Staff Report

To: Development Review Board
From: Michael Giguere, City Planner
Date: April 17th, 2025
Subject: Site plan review for a pocket park at 1 Main Street by the City of Essex Junction, owner.
File: SP# 4.2025

Project Title	One Main - City Park
Location	1 Main St. Essex Jct, VT 05452
Sheet Title	Conceptual Design
Scale	Sheet Scale
Sheet No.	L-01 of 1

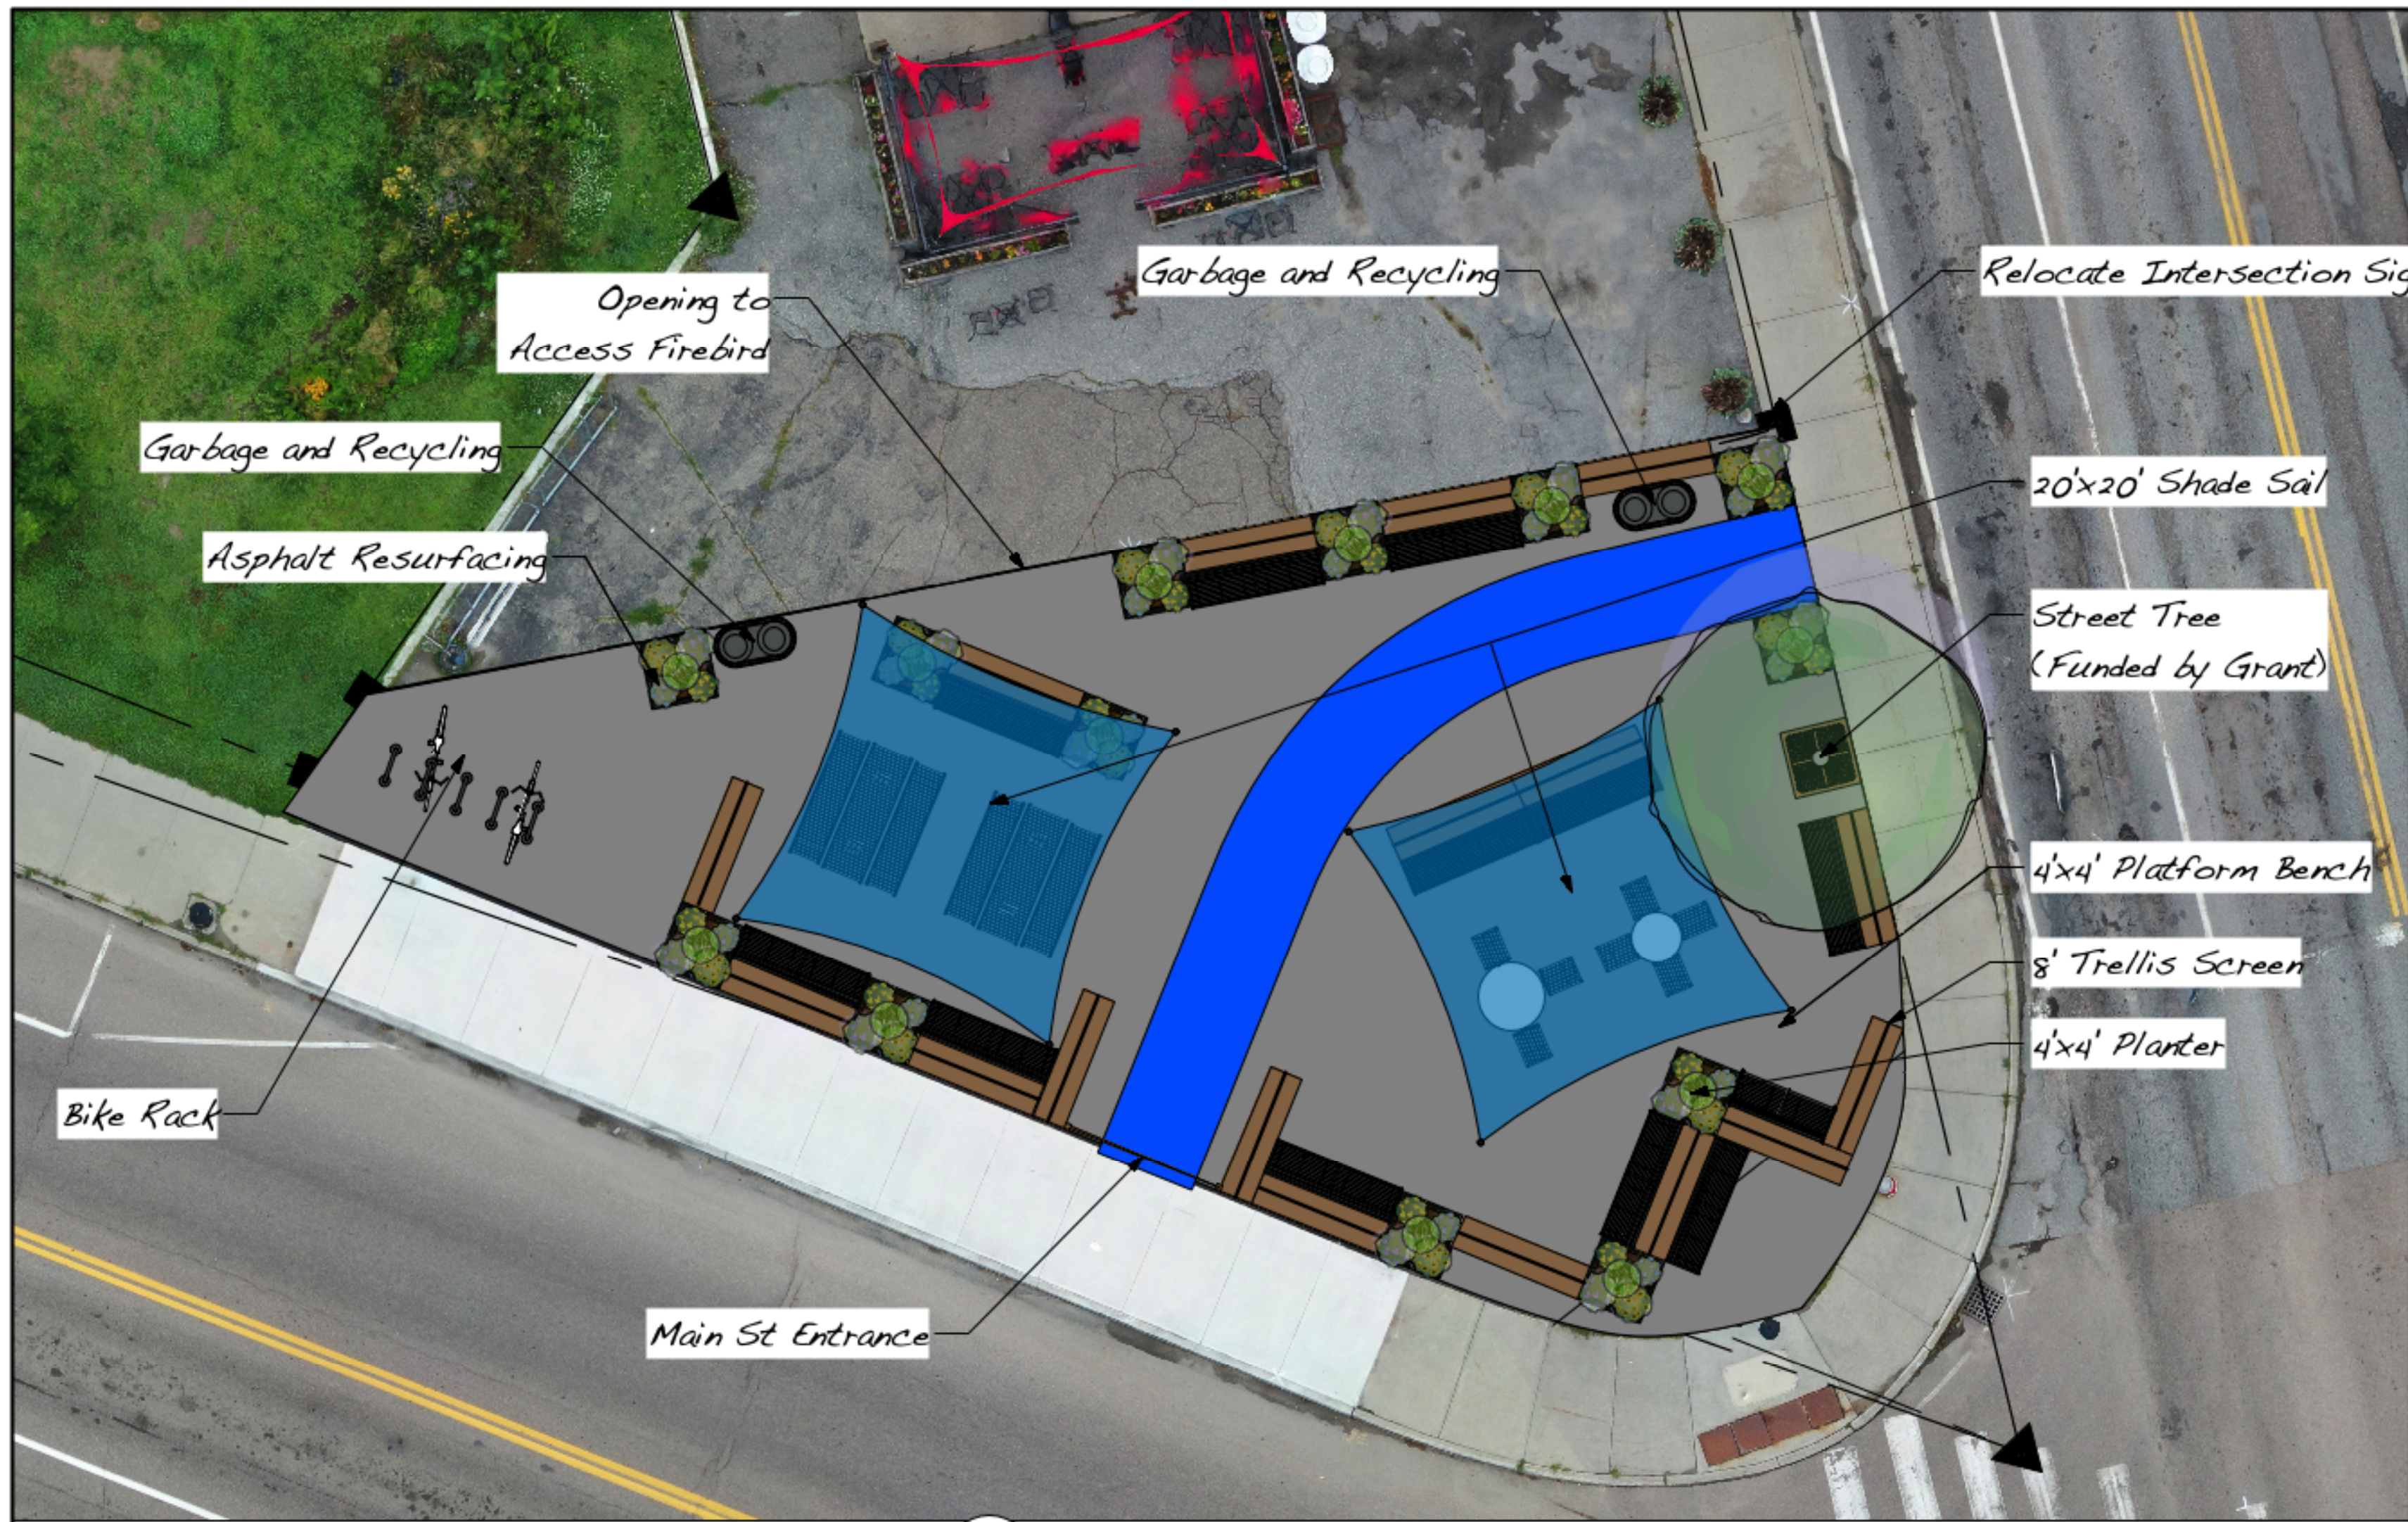
The light poles are the tallest proposed structures in the park at thirteen (13) feet tall, which meets district height requirements.

The applicant’s submitted lighting plan proposes two new light fixtures mounted at the top of two of the thirteen (13) foot sun shade poles, above the sun shade sails. At night, this will illuminate and filter through the sails, and the light fixtures are proposed to be put on an automatic on/off timer. Due to the orientation of the sails, the number of tall poles and light fixtures may increase to three (3) total.

The DRB should discuss the proposed lighting plan to confirm the design intention and impact on the surrounding area.
